**Addendum No. 3
December 7, 2018**

Project: Rock Valley Event Center and City Hall Remodel
Rock Valley, Iowa
Project number 1130.2762.17

Architect: Architecture Incorporated

13) DRAWING SHEET 8.20

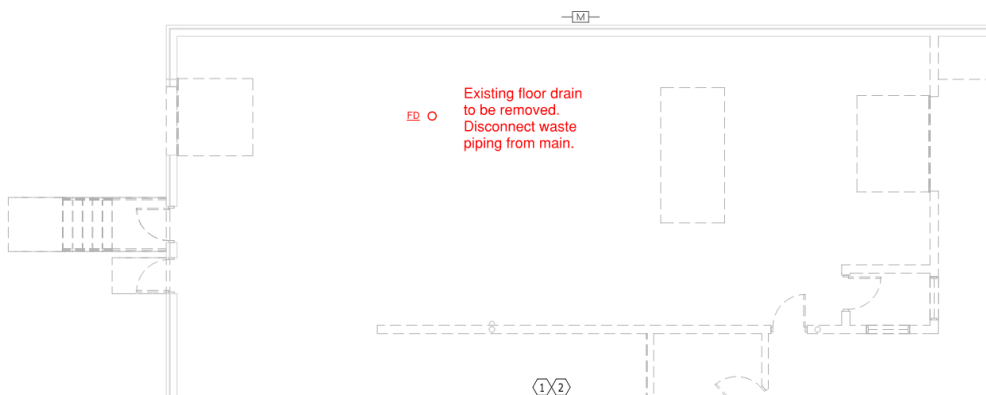
- 1. Remove floor drain and disconnect waste piping from main and cap. Coordinate concrete patching with General Contractor. See diagram below for approximate location of the floor drain.
